**CITY OF SAUSALITO**  
420 Litho Street, Sausalito, CA 94965

**Addendum No. 2**

Issued **June 14, 2023**

**For**  
**Bridgeway Slide Repair Below 268 Woodward Project**

SHEET  
1

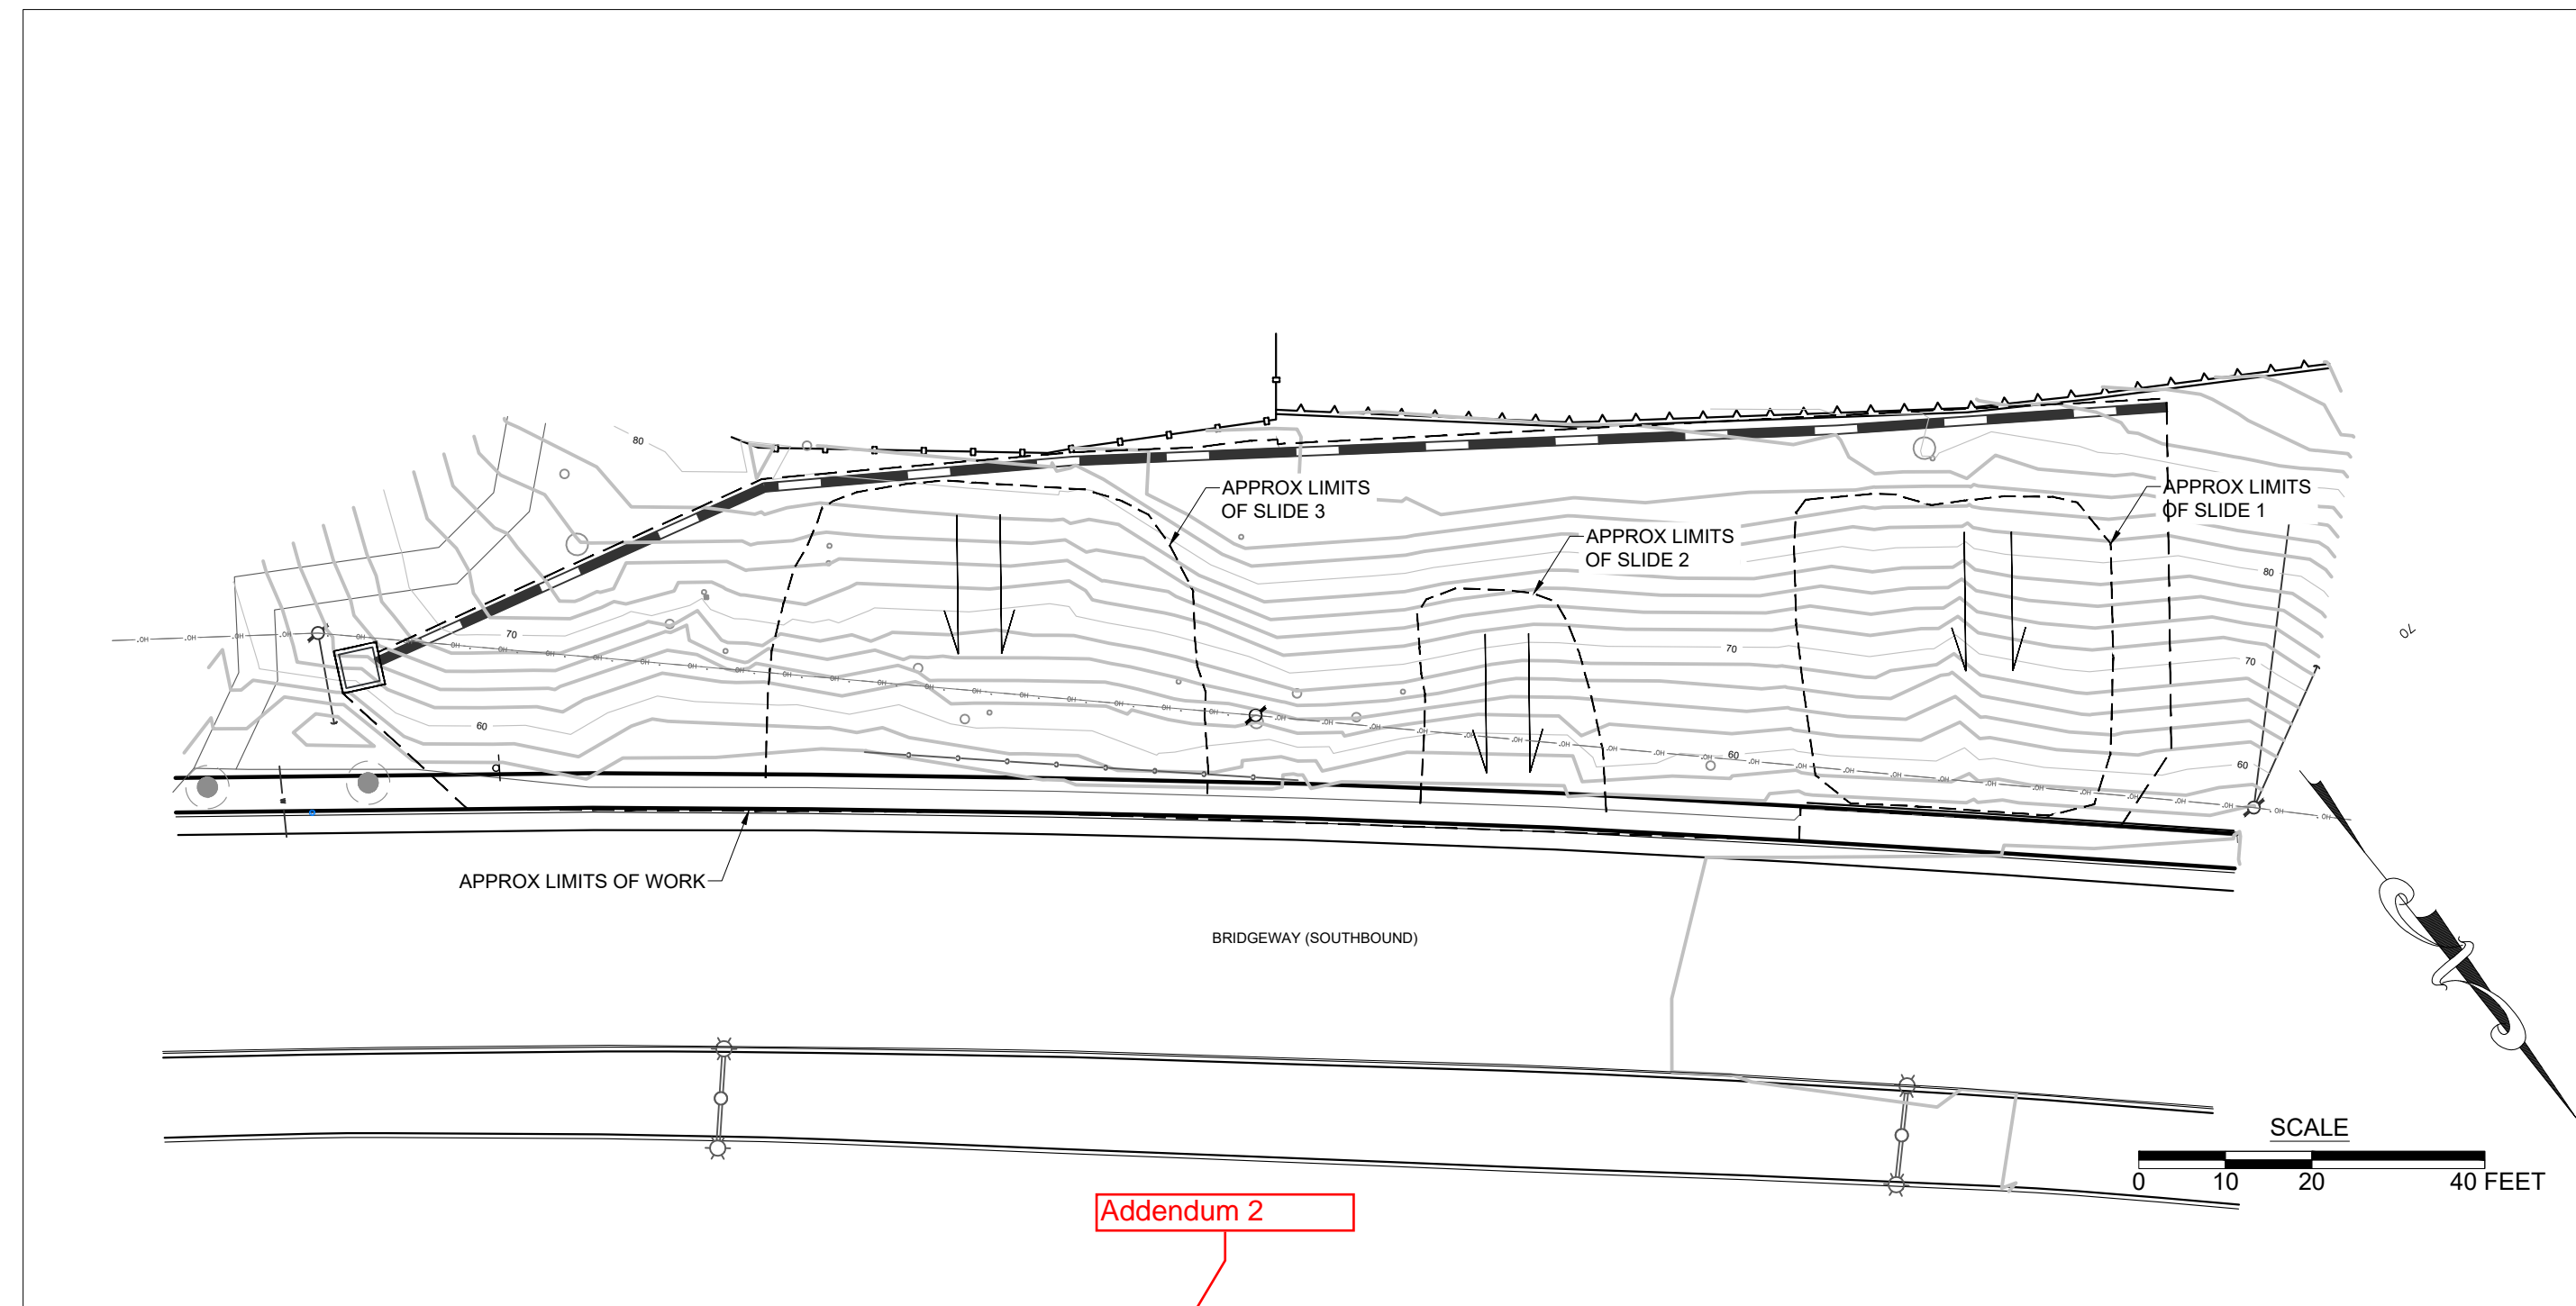
1. Sheets 1 and 4 have been revised and are attached. See clouded revisions, called out as "Addendum 2".
